ADDENDUM NO. 1

RE: CITY OF NOME - NACTEC HOUSE SIDING REPAIRS AND EXTERIOR PAINTING

Sheet A6.0 Wall Sections, dated 2007

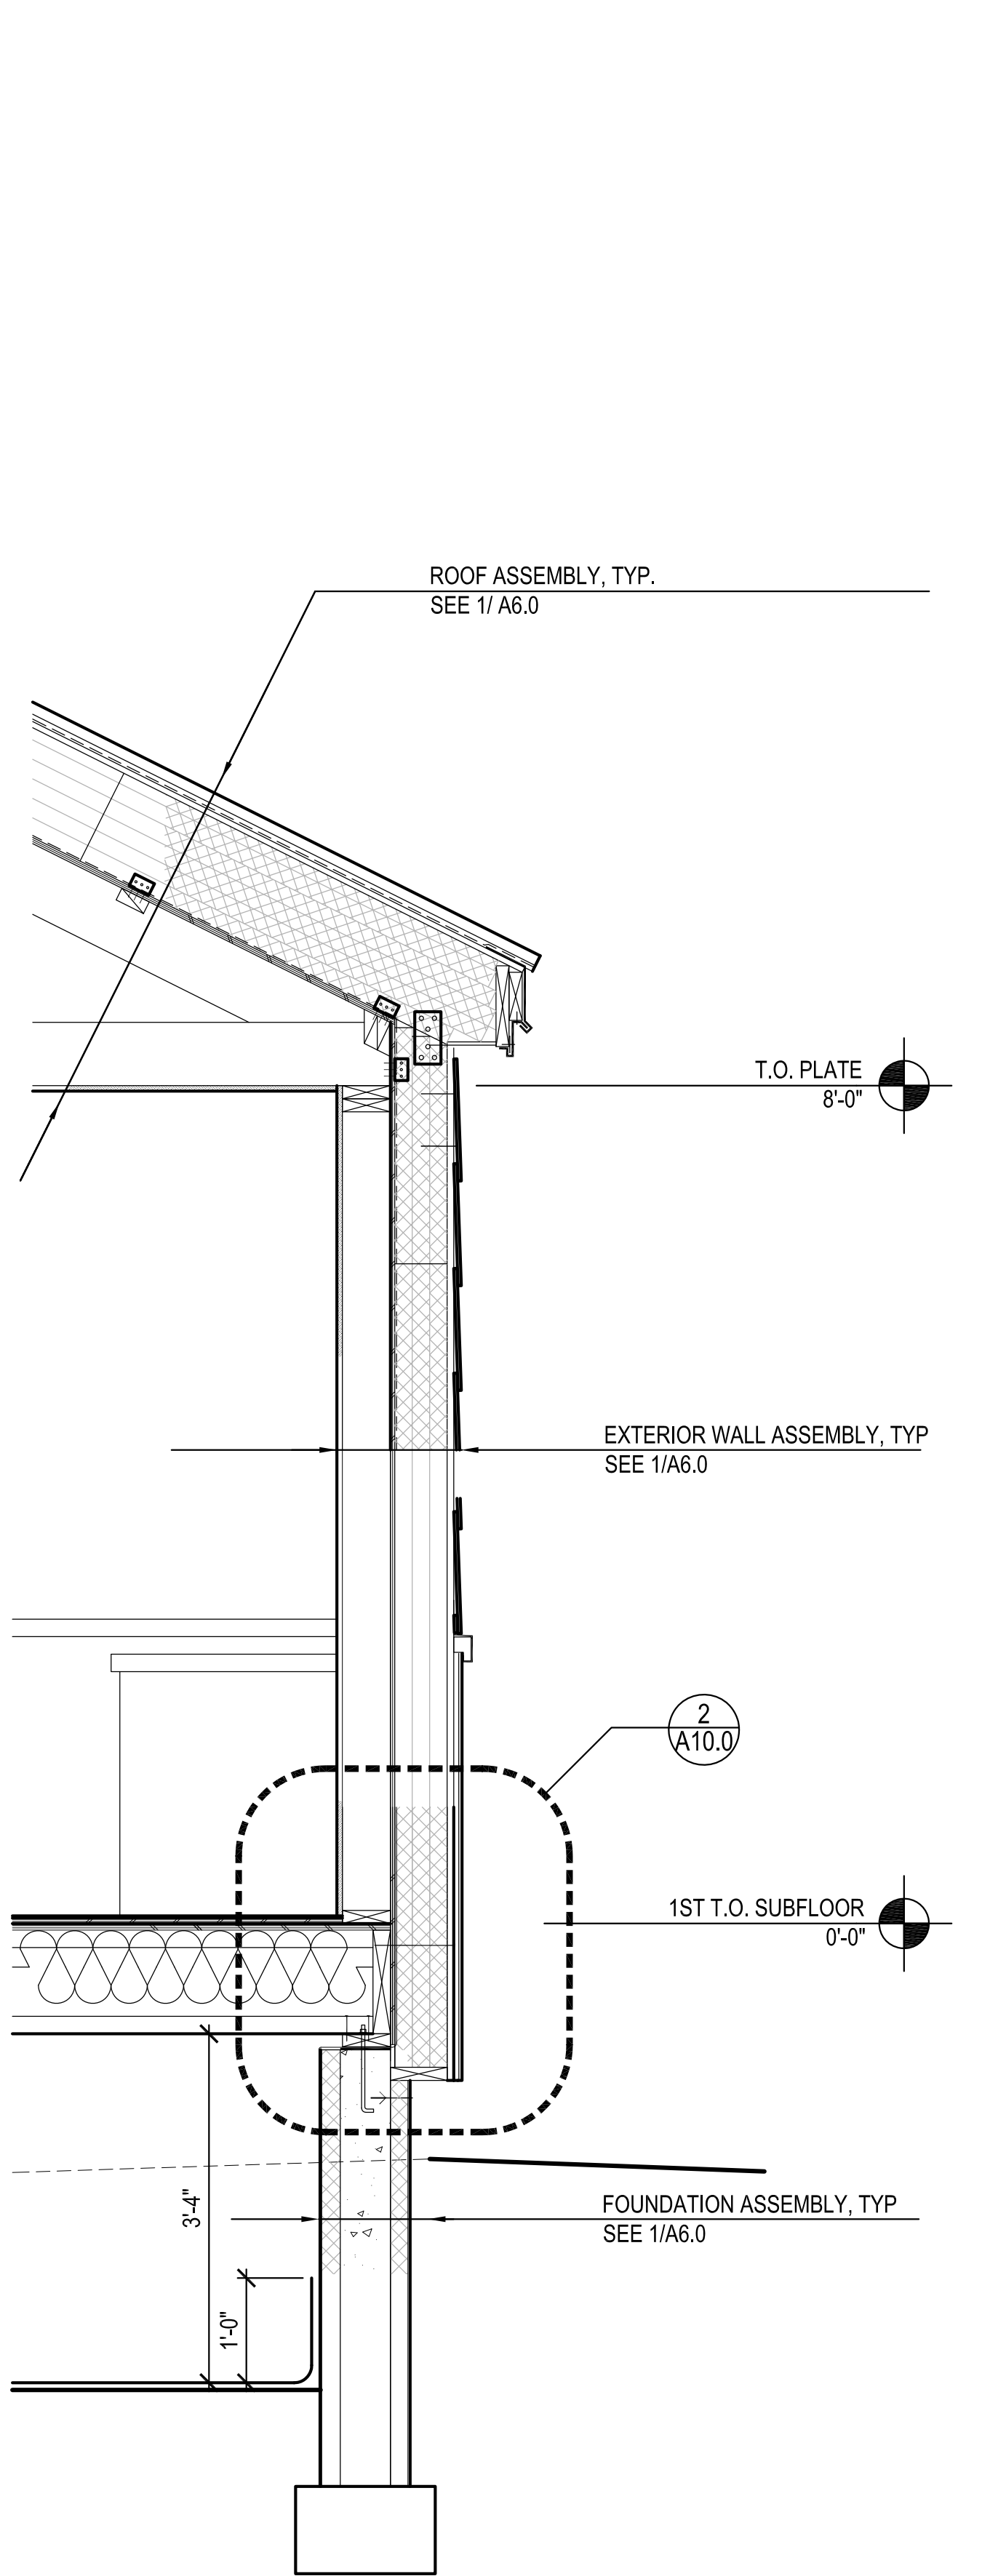
8. Where the fiber cement board is completely degraded around stair access locations, do you want to install new fiber cement board panels, or would you be open to metal?

- a. Is it your intent to have the Contractor remove the access stairs and replace the siding underneath or can all be left in place?

Answer: The west stair access shown in the bid document photos may be left with pressure treated timber exposed.

Answer: The Contractor may need to remove the steps in order to remove the damaged siding at that location.

SHEET #
A6.0

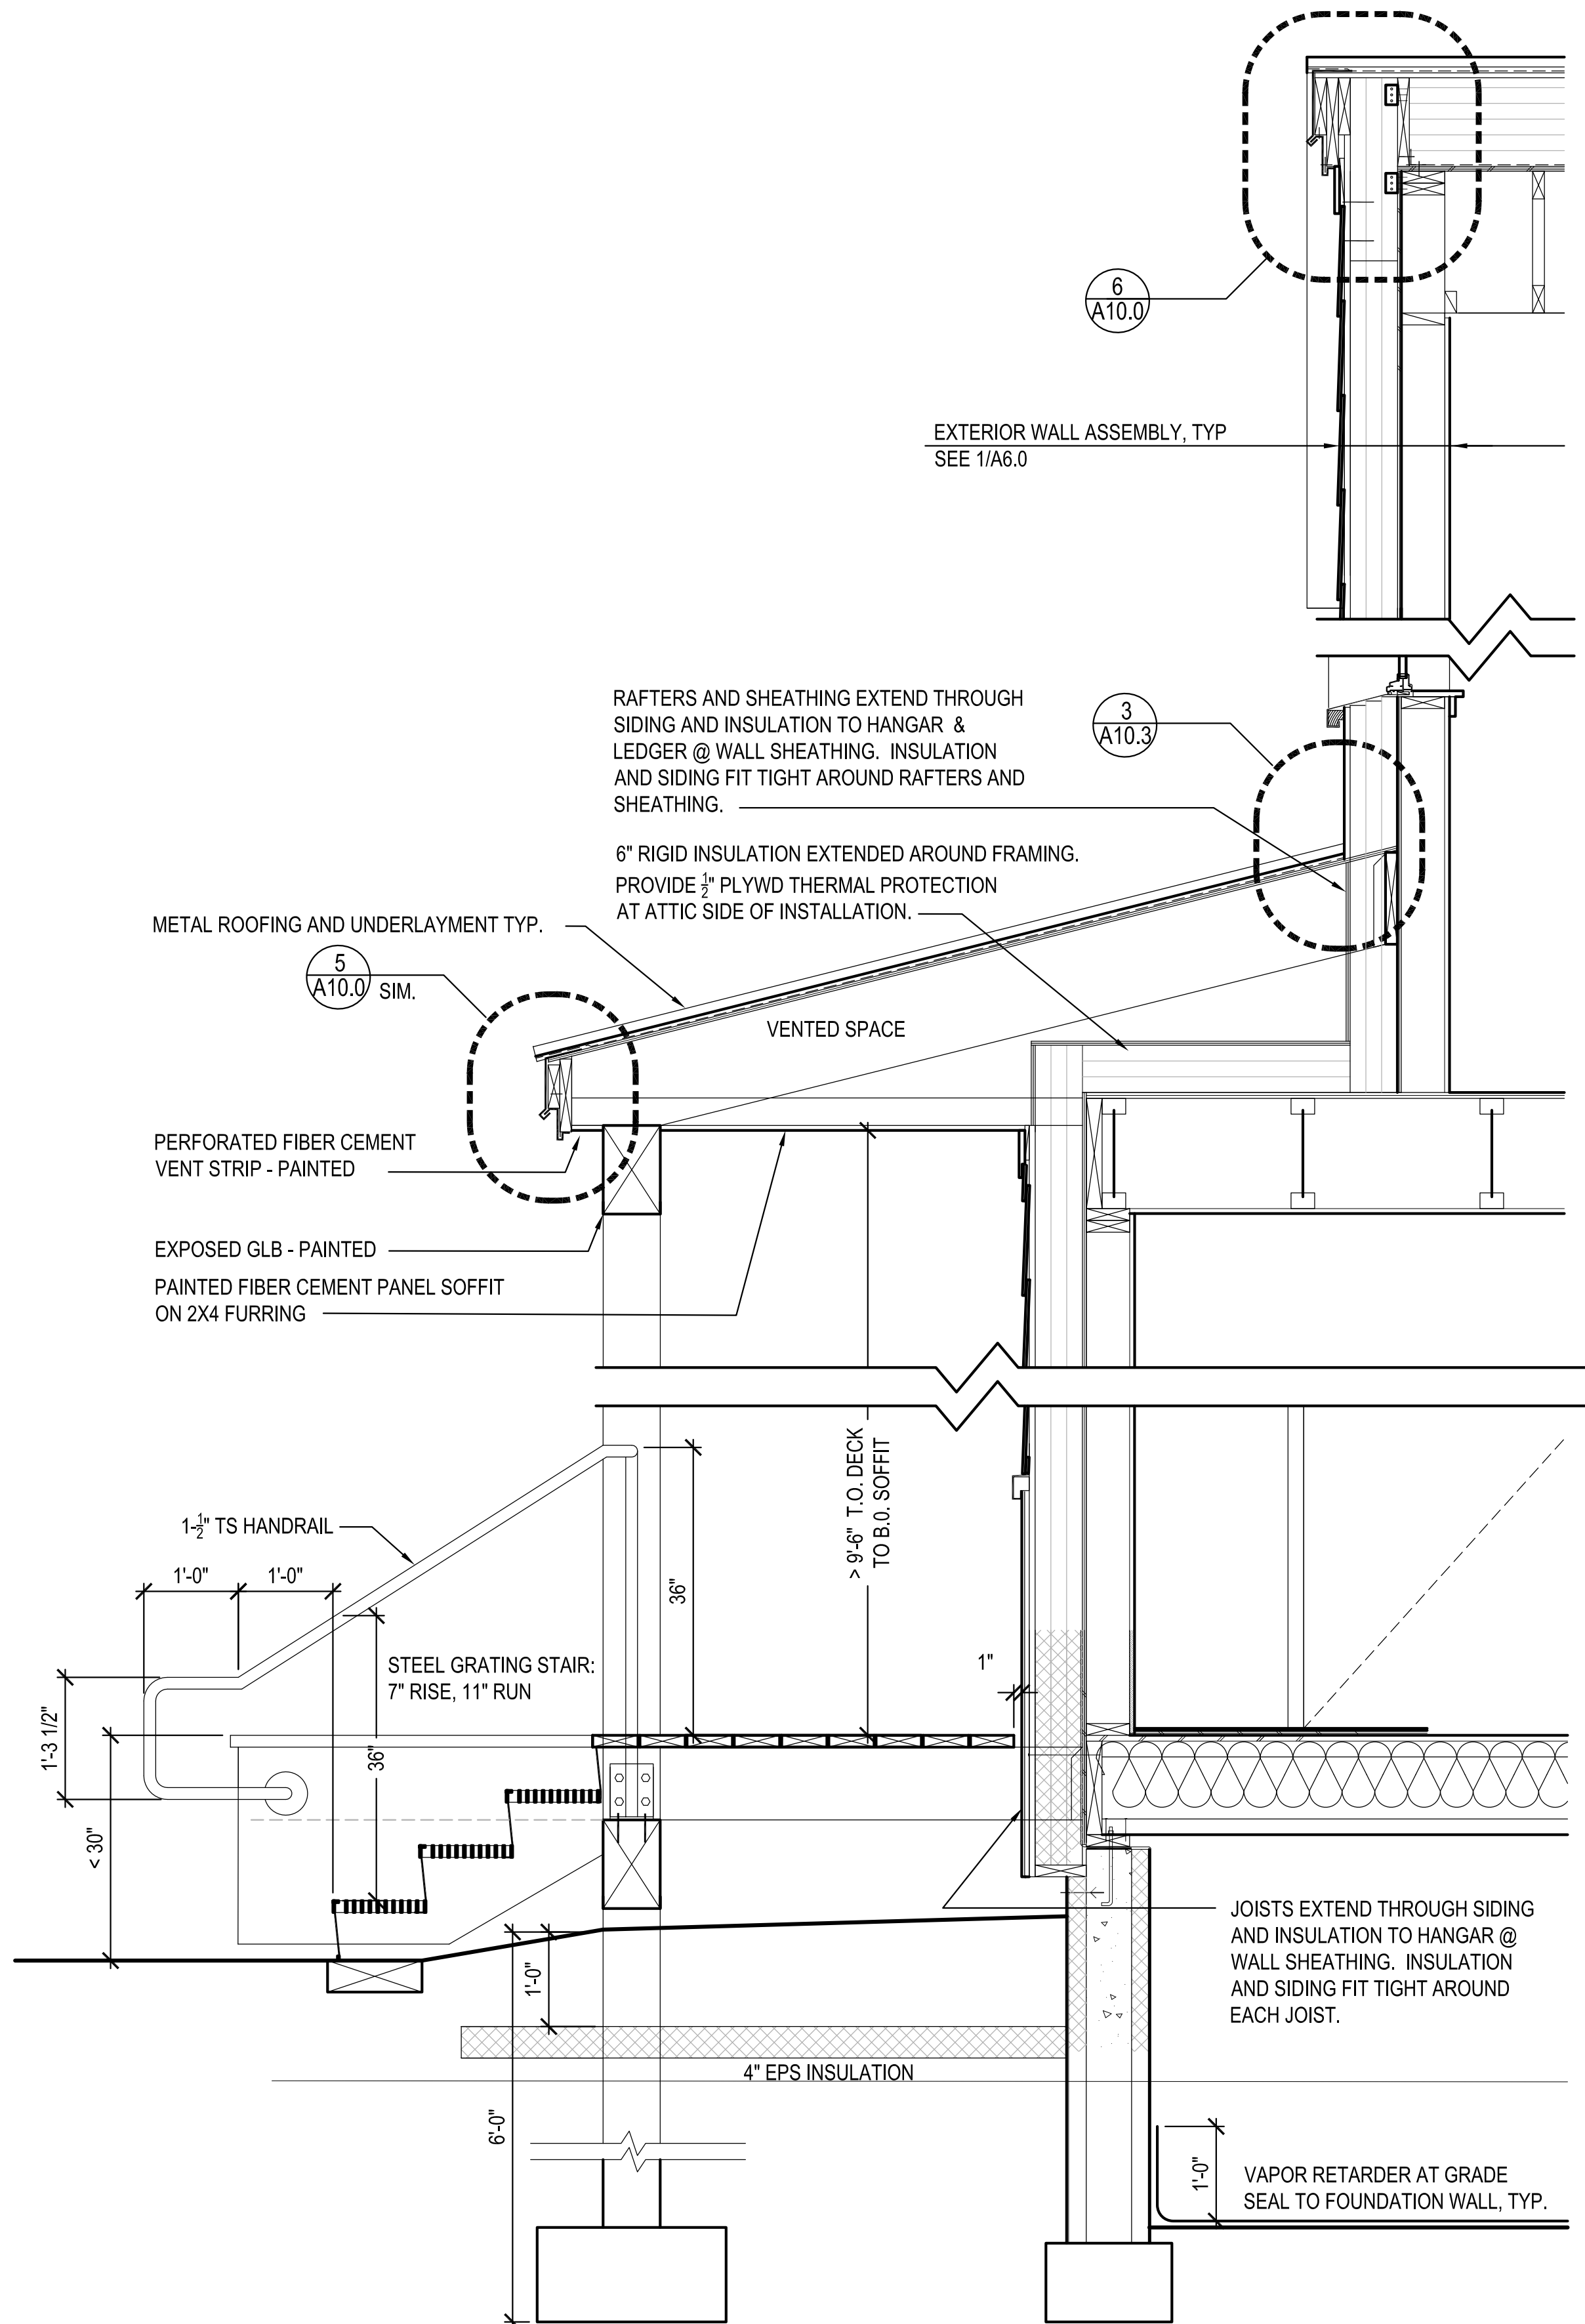
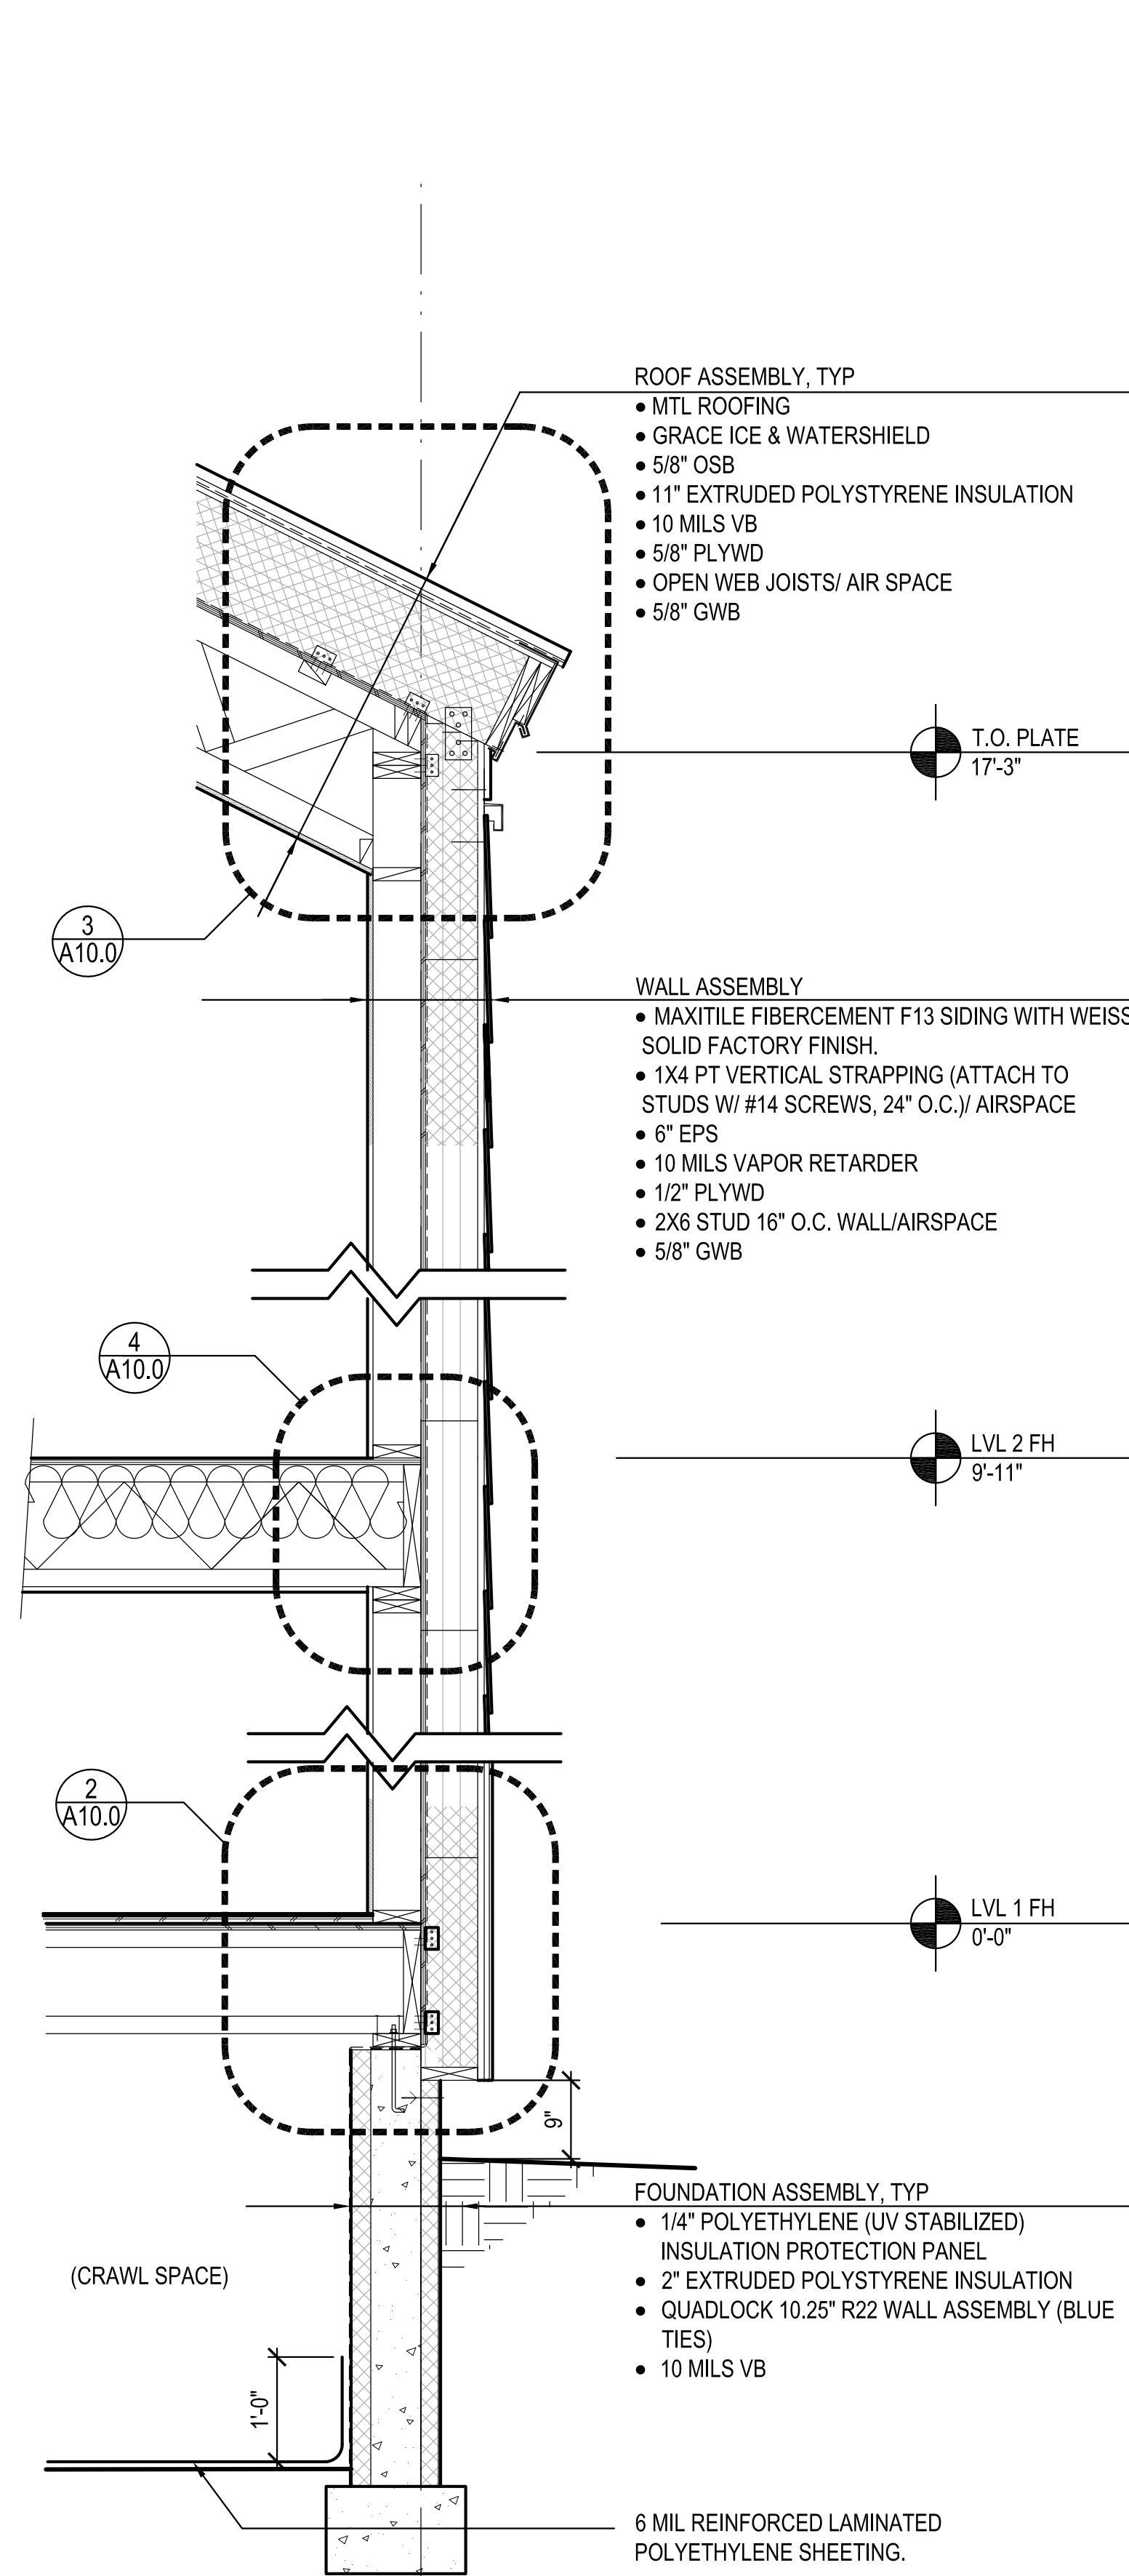
1. Is the substrate compromised – framing / sheathing?

5. Repair of building wrap where siding removed? Noted to utilize weather barrier tape.

Answer: The NACTECs building is outside insulated, meaning the vapor retarder and insulation is all outboard of sheathing. The siding is separated from the sheathing with:

- 10 mils vapor retarder (they may have just gone with ice and water shield as they did on the roof).
- 6” of rigid insulation board.
- 1x pt strapping creating a ¾” vertical air space.

It is highly unlikely in this assembly for any water to get to the structural sheathing and we do not anticipate damage to interior finishes resulting from the compromised siding. Please see the attached drawing A6.0 from the original construction.

Answer: Please see the attached drawing A6.0 from the original construction. The design did not call for building wrap between siding and strapping. The weather barrier tape is intended to seal flashings to substrates where an alternative material lap cannot be achieved. If, unknown to us, the original builders added weather barrier outboard of the insulation, it should be repaired where damaged.
